DESIGN EXCEPTION #DE14-02

RE: Exception from Driveway Spacing Criteria at Mesa County Community Services

Ref: Design Exceptions Mesa County Community Services Building File # ANX-2002-100

See Exhibit "A" for clarification.

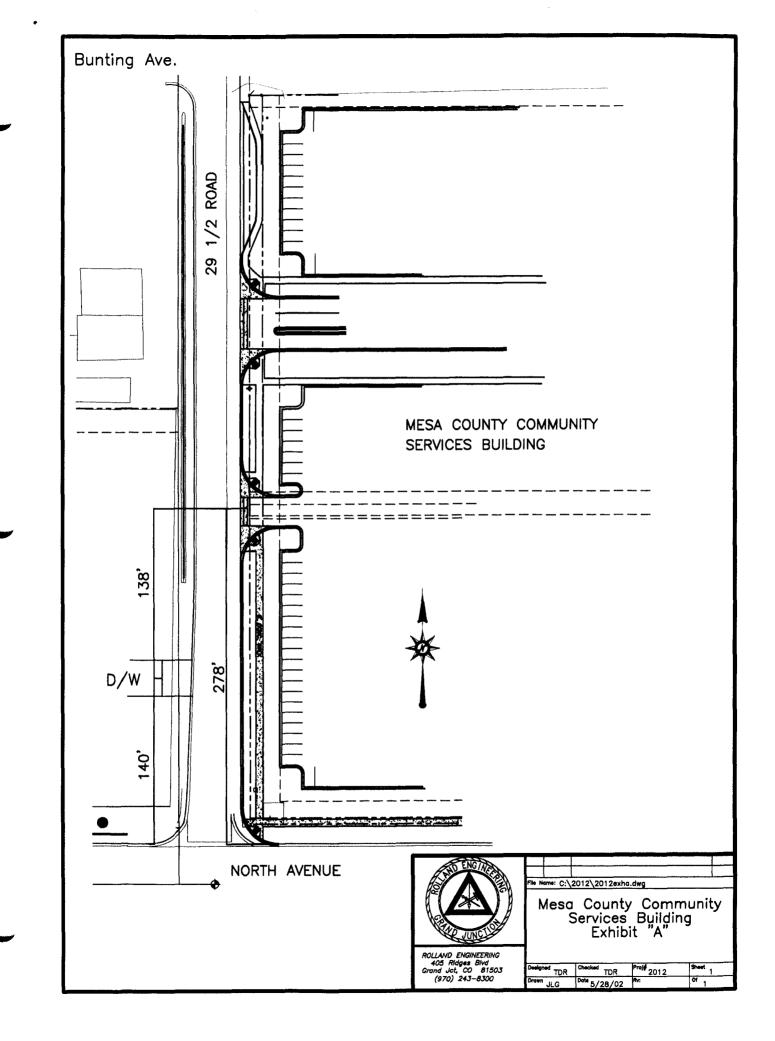
This letter is written to request a design exception per Chapter 14 of the Transportation Engineering Design Standards (TEDS). We are requesting an exception to Access Design and Site Circulation Section 4.1.2 Offsets. More specifically the requirement for 150 feet of offset from an access on the opposite side of 29 $\frac{1}{2}$ Road from our property.

As you are aware, our proposed site calls for two accesses to our property. The north access is the primary access with the southern access intended for employee, delivery, and emergency purposes. Along the 29 $\frac{1}{2}$ road frontage of our property there exists one access to properties on the opposite side, this access lies 138 feet (the exception) south of our southern secondary access.

Alignment of our access with the existing access not only would not work for our site access and circulation needs but would violate TEDS Section 4.1.3 corner clearance (250 feet) from North Avenue. Our southern access can not move north because it is 150 feet (Section 4.1.1 Spacing) between our two access locations.

It does not appear to us that this exception will have any impact on the safe access to our site, or to the opposite site. The offset provided is within 8% of the standard. The existing opposite access is to a small used car sales lot that fronts North Ave. and has access on its North Ave. frontage. Additionally in conversations with the owner of the opposite properties he has indicated plans for additional development at which time he will need to comply with TEDS section 4.1.3 Corner Clearance.

I RECOMMEND THAT WE APTROVE THUS

EXCEPTION .

See Exhibit "A" for clarification.

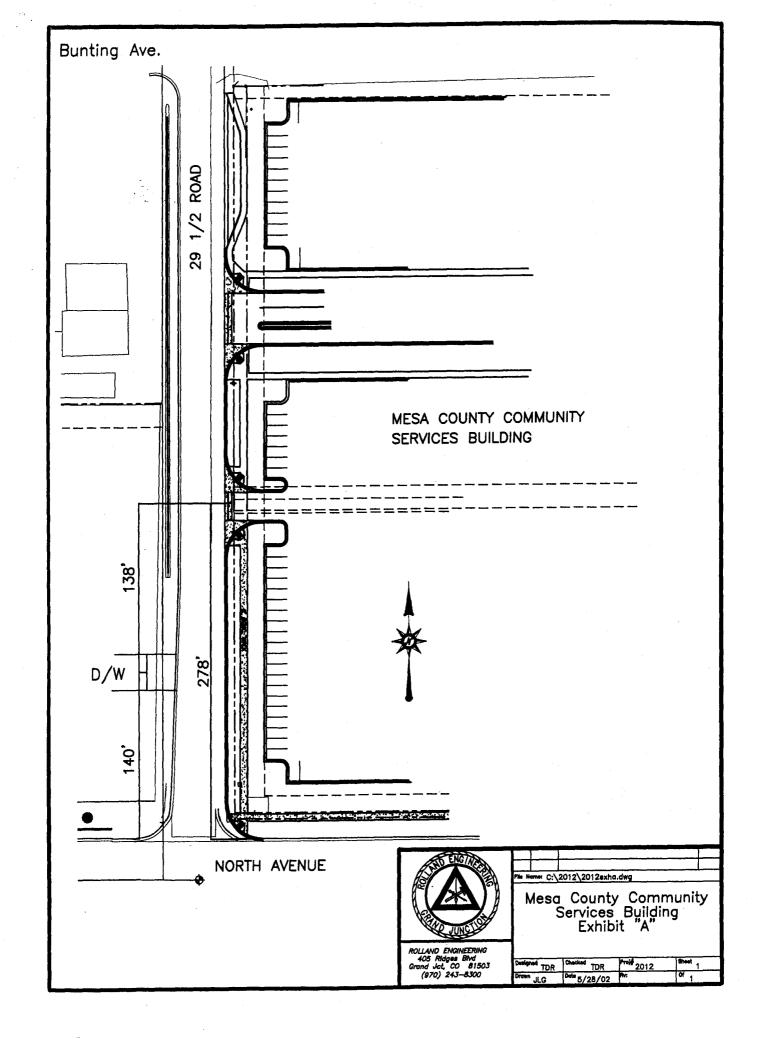
This letter is written to request a design exception per Chapter 14 of the Transportation Engineering Design Standards (TEDS). We are requesting an exception to Access Design and Site Circulation Section 4.1.2 Offsets. More specifically the requirement for 150 feet of offset from an access on the opposite side of 29 ½ Road from our property.

As you are aware, our proposed site calls for two accesses to our property. The north access is the primary access with the southern access intended for employee, delivery, and emergency purposes. Along the 29 ½ road frontage of our property there exists one access to properties on the opposite side, this access lies 138 feet (the exception) south of our southern secondary access.

Alignment of our access with the existing access not only would not work for our site access and circulation needs but would violate TEDS Section 4.1.3 corner clearance (250 feet) from North Avenue. Our southern access can not move north because it is 150 feet (Section 4.1.1 Spacing) between our two access locations.

It does not appear to us that this exception will have any impact on the safe access to our site, or to the opposite site. The offset provided is within 8% of the standard. The existing opposite access is to a small used car sales lot that fronts North Ave. and has access on its North Ave. frontage. Additionally in conversations with the owner of the opposite properties he has indicated plans for additional development at which time he will need to comply with TEDS section 4.1.3 Corner Clearance.

I RECOMMEND THAT WE APPROVE THUS EXCEPTION,
